ADDENDUM # 2
December 2, 2020
Union County Community Center
Renovations / View Grill Expansion Project
Project# UC-2020-11-01

This addendum is issued to change or clarify the proposal documents associated with the Union County Community Center Renovations/View Grill Expansion Project. Issued November 11, 2020

This addendum is being issued to incorporate the following information into the Drawings (Issued October 30, 2020) for the referenced project.

A-1.00

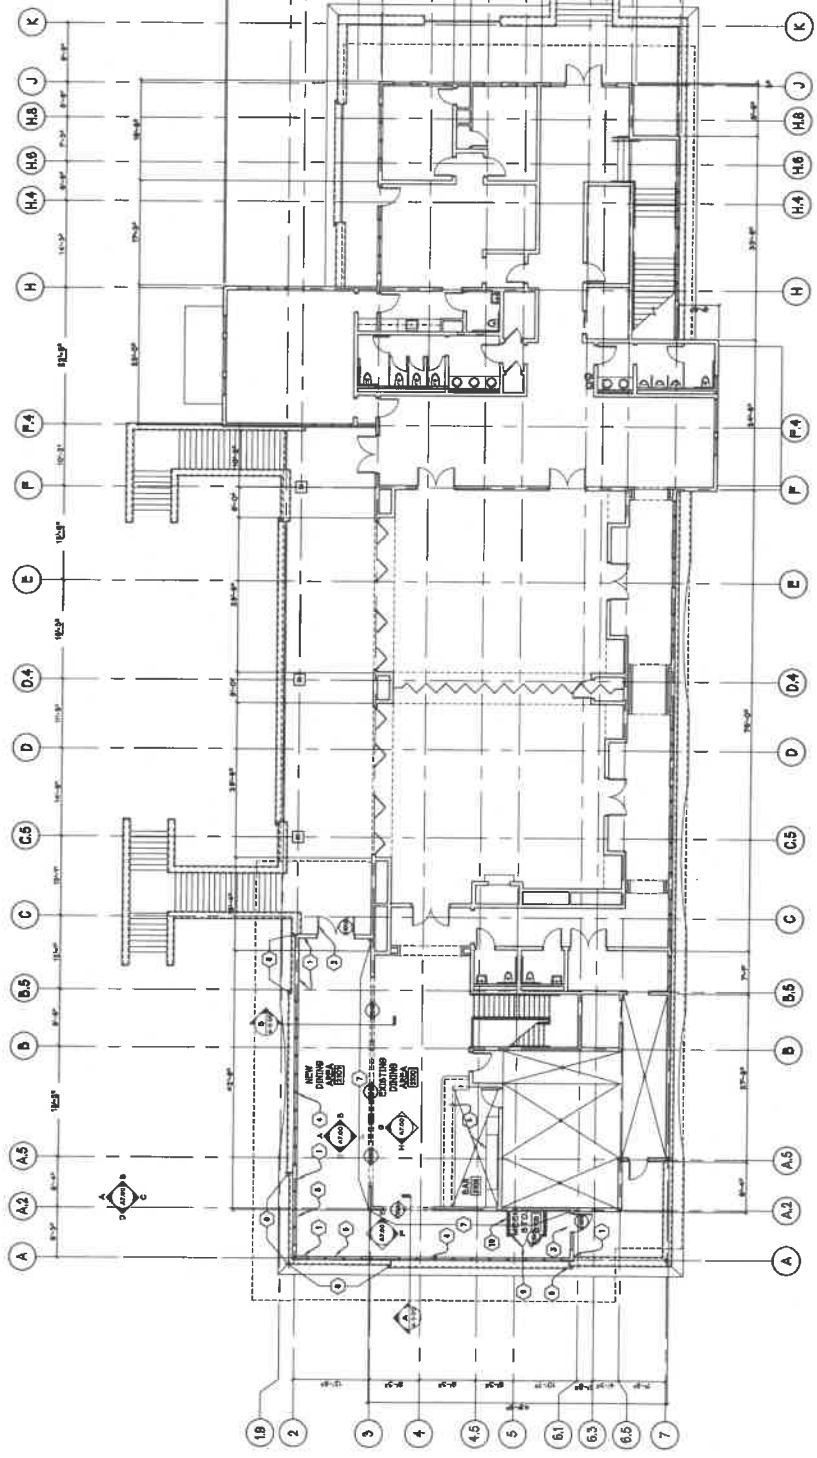
6. The Roof Framing Plan on Sheet S-2.1 shows the HSS beam to stop at roughly column line 6.1 and B.5 on each end of the roof expansion. The Upper Level Floor Plan on Sheet A-1.00 seems to show support wall framing stopping at the same location as the HSS beam near column line 6.1 and continuing on to roughly column line C on the other side. It appears that the purpose of the HSS is to span across window openings with there being a short distance of framed walls to support the roof structure. I am not seeing what supports the roof structure from column line 6.1 to 6.5 or C to C.5? Can you please clarify what supports the roof structure in these areas? (the column lines referenced are just to give a general location) **SEE ADDENDUM ITEM 4**

7. Note 7 on Sheet A-1.00 says "Existing EIFS wall finish to remain. Clean and repair as required" but both Sections A and B on Sheet A-3.01 say "Apply new gypsum board to existing

wall structure". Can you please advise if the existing EIFS remains or if new gypsum board should be installed? ***SEE ADDENDUM ITEM 4***

A-2.00

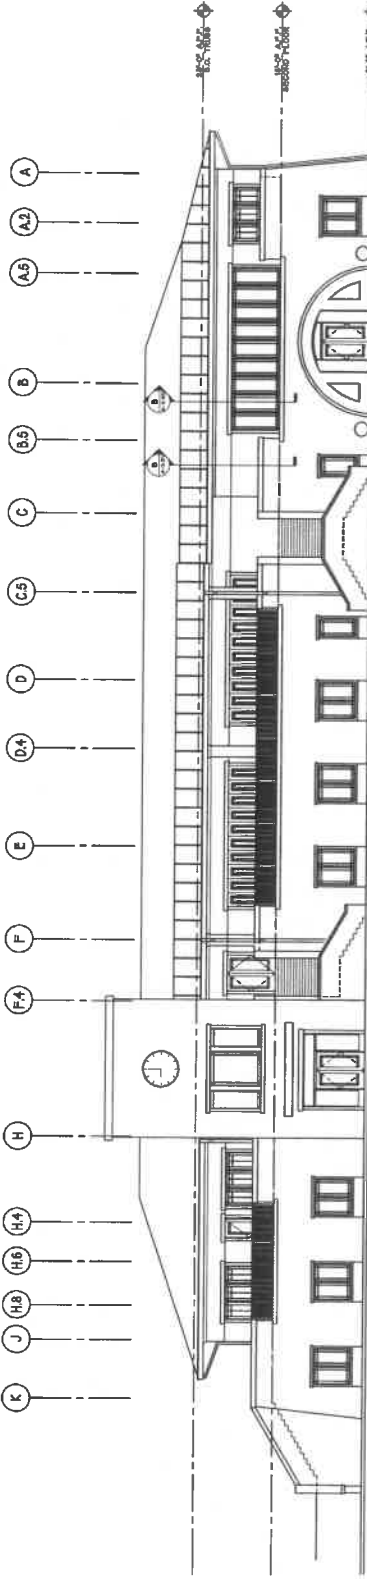
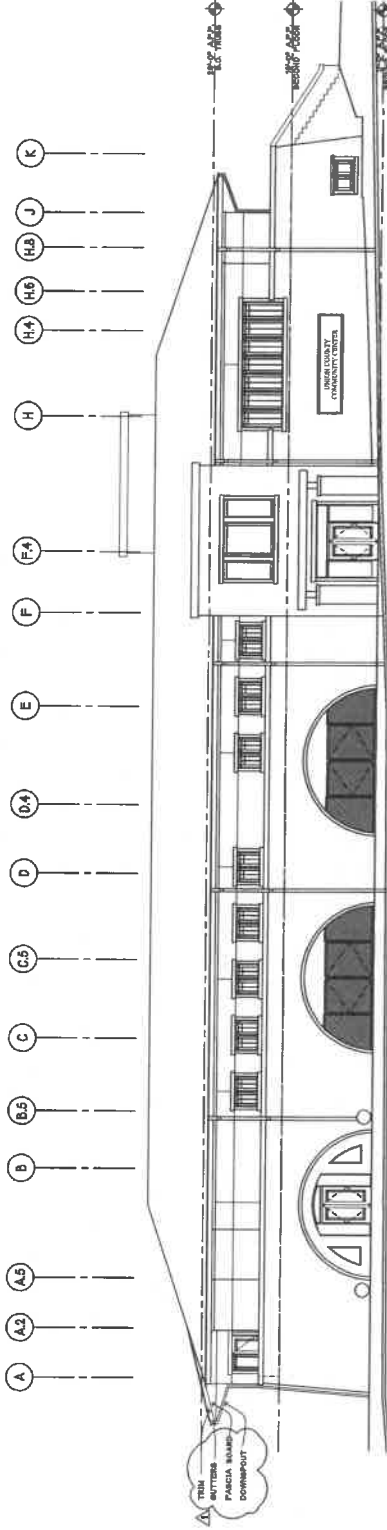
5. The South Elevation on Sheet A-2.00 appears to show a hipped roof for the expanded roof but the East Elevation on Sheet A-2.01 seems to show a gable type roof. The Roof Framing Plan on Sheet S-2.1 also appears to show a gable type roof. Can you please clarify the style of roof that is intended? Also, If the desired style is a gable can you give some feedback as to how it should be finished? **SEE ADDENDUM ITEM 4**
